Public consultation/feedback report

Maioro Street Dynamic Lanes and Safety Improvements

Diagram of the proposed changes to New Windsor Road Intersection

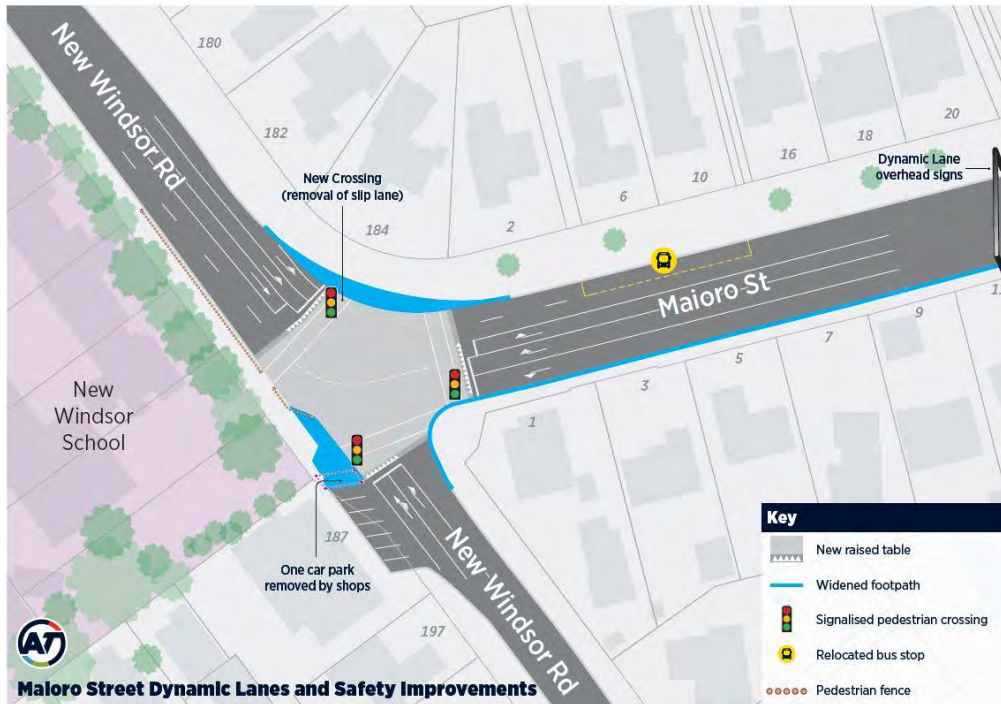
I agree strongly with all of the proposed changes, and hope that these will not be compromised on. This is a terrifying intersection to use in the morning and evenings. It's good to see the slip lane gone, and increase the width of the footpath.

Great to see the slip lane going and encouraging to see your willingness to drop a car park in favour of a better pedestrian experience.

Those not in favour of the changes, expressed concern about congestion, removing the slip lane (slowing traffic on the corner) and the raised table. Some thought that the pedestrian facilities in the area were already adequate.

raised tables do not keep Auckland moving, neither does removing a slip lane

The location does not need a raised intersection or signaled pedestrian crossing. The existing situation is sufficient for pedestrians to cross the road. Traffic already has to drive at a safe speed through the intersection, and slow down as turning the corner at the lights. This would not make pedestrians any safer than already are.

- Including crossing facilities/options for cyclists and other modes

- Improving the pedestrian fence to a more robust option
- Reducing the width of the intersection or changing the alignment to keep the 1x car park
- Ensuring the phasing optimises the throughput of traffic and is safe for pedestrians
- Not installing a speed table at this intersection

The feedback received is being considered as the project team investigate the feasibility of some of these suggestions, Options being considered will have to meet the outcomes of improved public transport experience and pedestrian connections.

Diagram of the proposed changes to Cordelia Place and Roseville Street

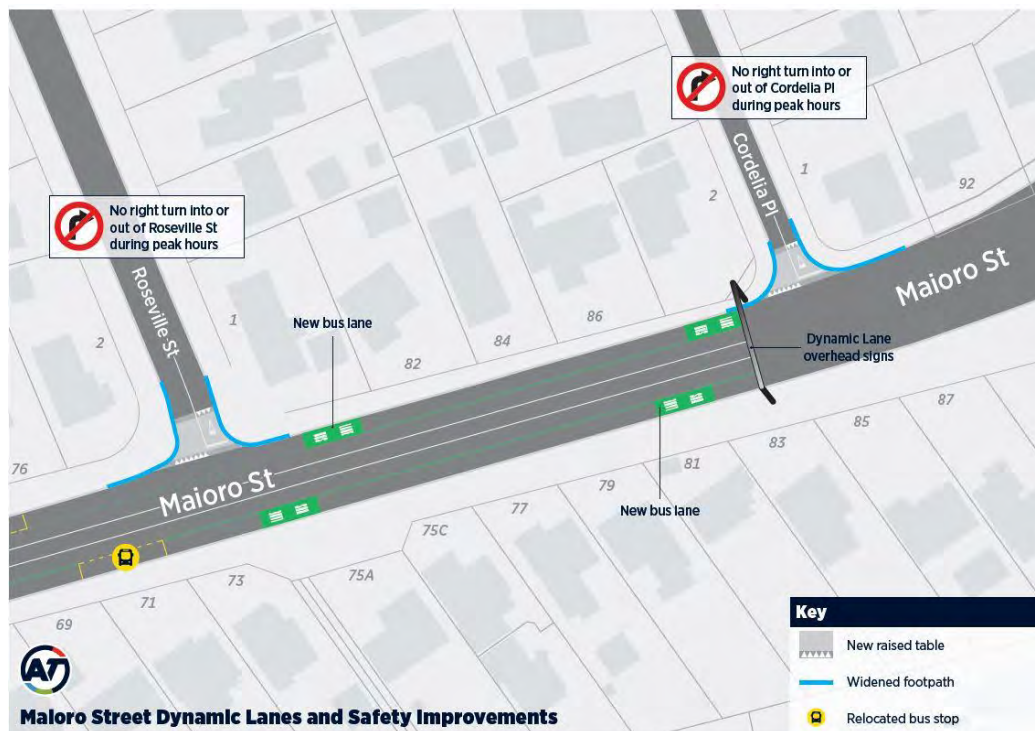
Some residents in this part of the project area had concerns about vibrations and noise already caused by heavy vehicles and buses, and are concerned that these changes could add to the vibrations and noise they already experience. Others expressed concern about the inconvenience that could be caused for residents who currently make right turns, and concern that these changes may increase the level of traffic on back streets.

Even though this change increases the safety at Roseville Street and Cordelia Place, I am not sure about the change at Cordelia Street. I don't know how easy or difficult it will be for the residents of Cordelia Place get into their street with this restriction.

I dislike raised tables, I find them to be more hazardous than helpful as I'm dividing my attention between the table and the upcoming traffic

- Extending no parking restrictions down the entrance to the side streets to allow more visibility
- Formalising the speed table into a pedestrian crossing
- Keeping the right turn, – but no speed table
- Keep the speed table, but allowing right turns in peak
- Move the speed table further down Roseville, around number 7
- Adding the speed table treatment to Laburnum and Netherton exits onto Richardson Road

Maoro Street and New Windsor Road intersection improvements

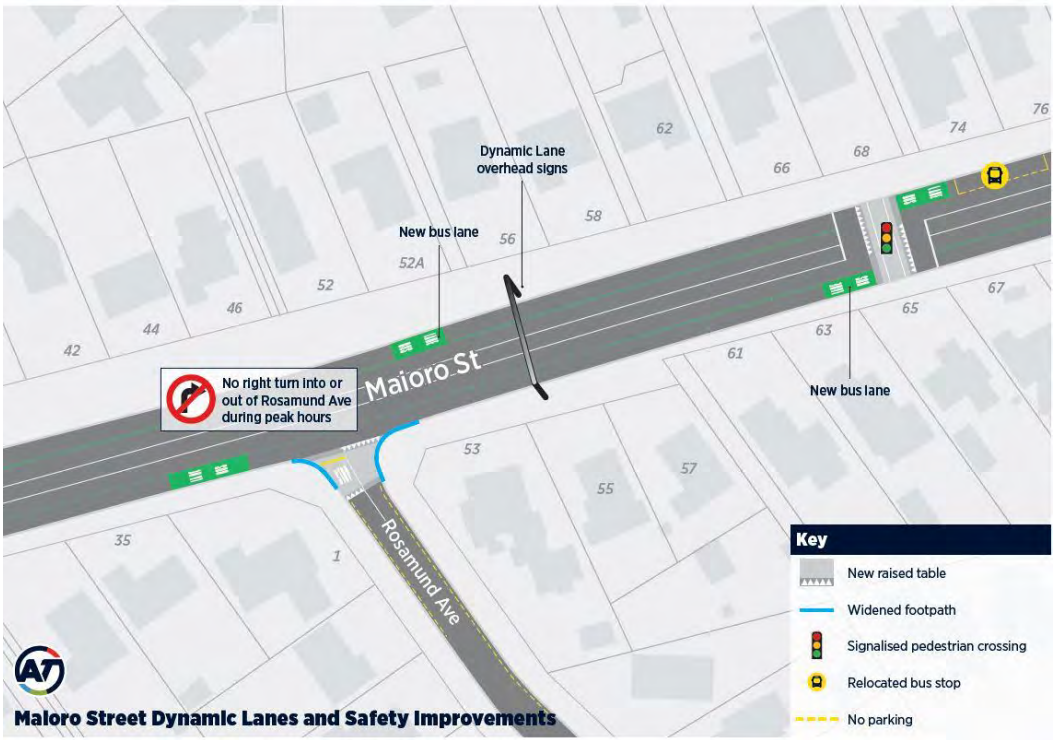
Design suggestion in feedback	AT response
<ul style="list-style-type: none"> - Reducing the kerb radius at the intersection may make it difficult for heavy vehicles to turn within the lanes and not track across the extended footpaths. 	
<p>Lane width</p> <ul style="list-style-type: none"> - Concerned that the dynamic lane in the middle will be narrower than the outside lanes. The traffic is already congested and I believe it will be worse with dynamic lanes 	<p>[AT response]</p> <p>The proposed design includes remarking all the lanes so they would be of equal width, appropriate for vehicle lanes. The lanes would also be marked with LED lights for the dynamic changes.</p> <p>However following design suggestions and feedback from the community we are investigating and reviewing the feasibility of the suggested improvements, which may lead to changes to the proposal. This concern raised will be taken into consideration with any changes.</p>
